FREDERICK COUNTY PLANNING COMMISSION
September 8, 2021

TITLE: Crestwood Manor

FILE NUMBER: S-1171 AP PL264042, A264016, F264020, F264021

REQUEST: **Combined Preliminary/Final Plat Approval**
The Applicant is requesting Combined Preliminary/Final Plat approval to subdivide a 9.52-acre Site into 2 lots.

Graphic #1

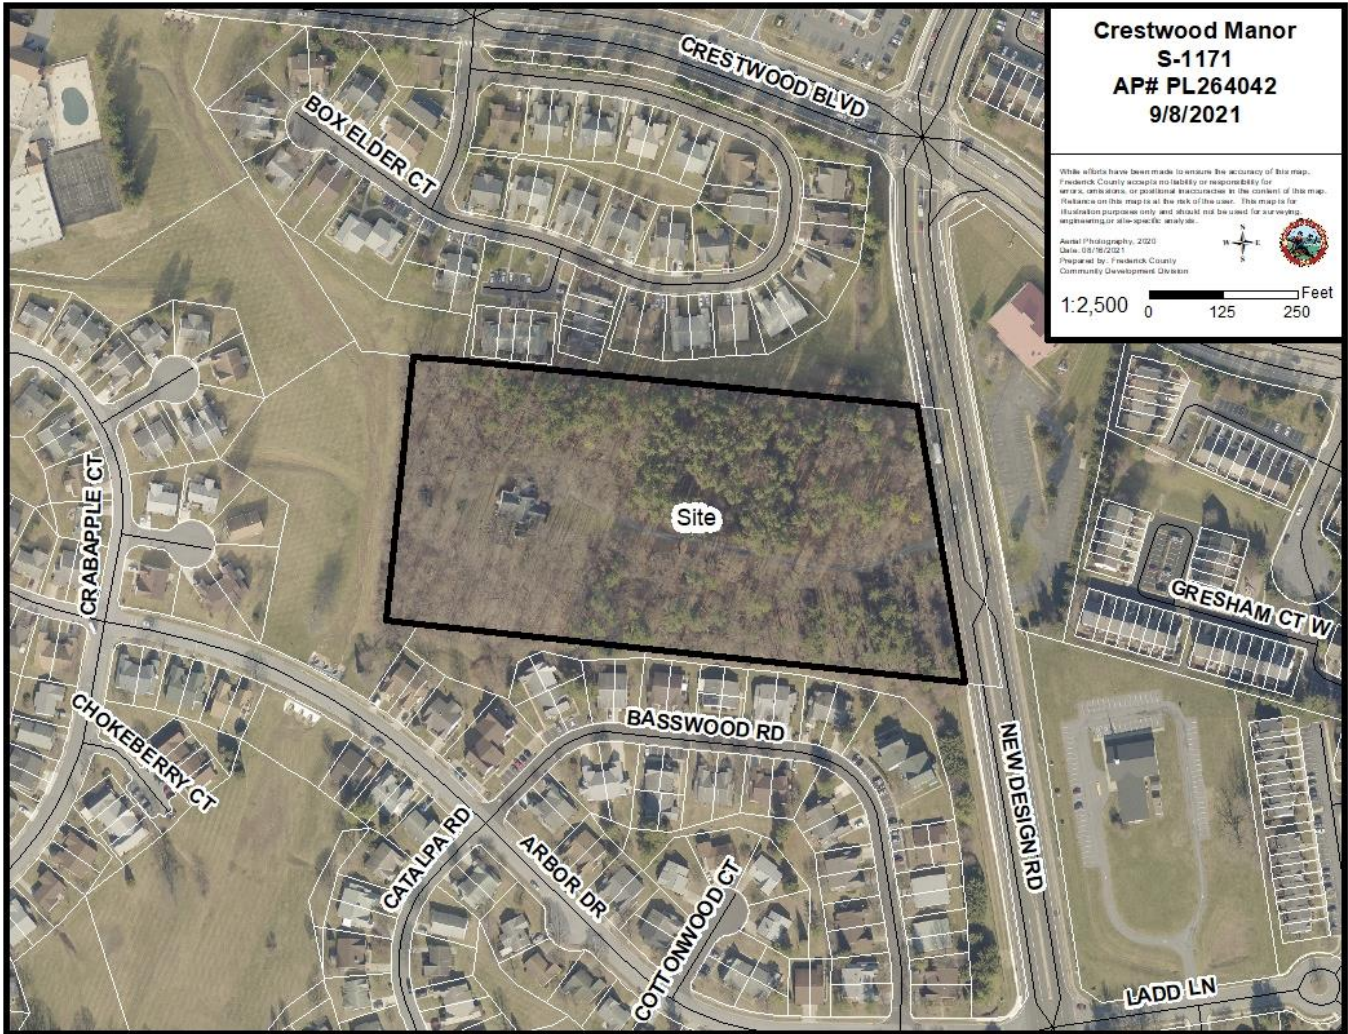
The property is covered in vegetation with the existing house situated at the rear of the Site. In addition to the house, there is an existing garage and smoke house. There is a single access from New Design Road. The driveway loops around the existing carport. See Graphic #1 & 2.

Graphic #3: Zoning

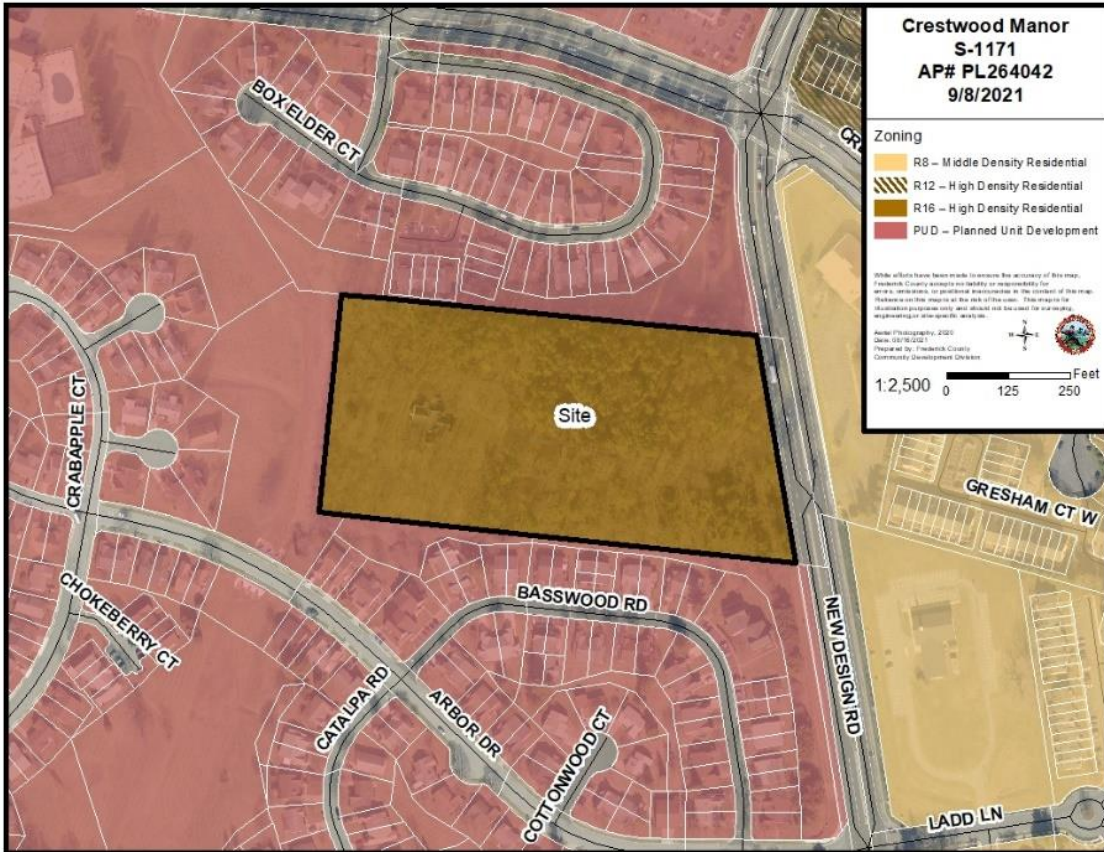
High Density Residential R-16: 40 ft. front yard, side and rear yards are equal to the height of the building. The maximum height is 100 ft. There is no minimum lot area and the minimum lot size is 2,700 sq. ft. per unit. The Applicant is providing 2,828.5 sq. ft. per unit for lot 1 and 4,035.85 sq. ft. per unit for lot 2.

The proposed lots meet the minimum lot size requirement (Lot 1 is 169,710 sq. ft. and Lot 2 is 242,151 sq. ft.). The required front, rear, and side setbacks are shown and noted on the plan and meet the Zoning Ordinance requirements.

The proposed subdivision will meet all Zoning Ordinance requirements.
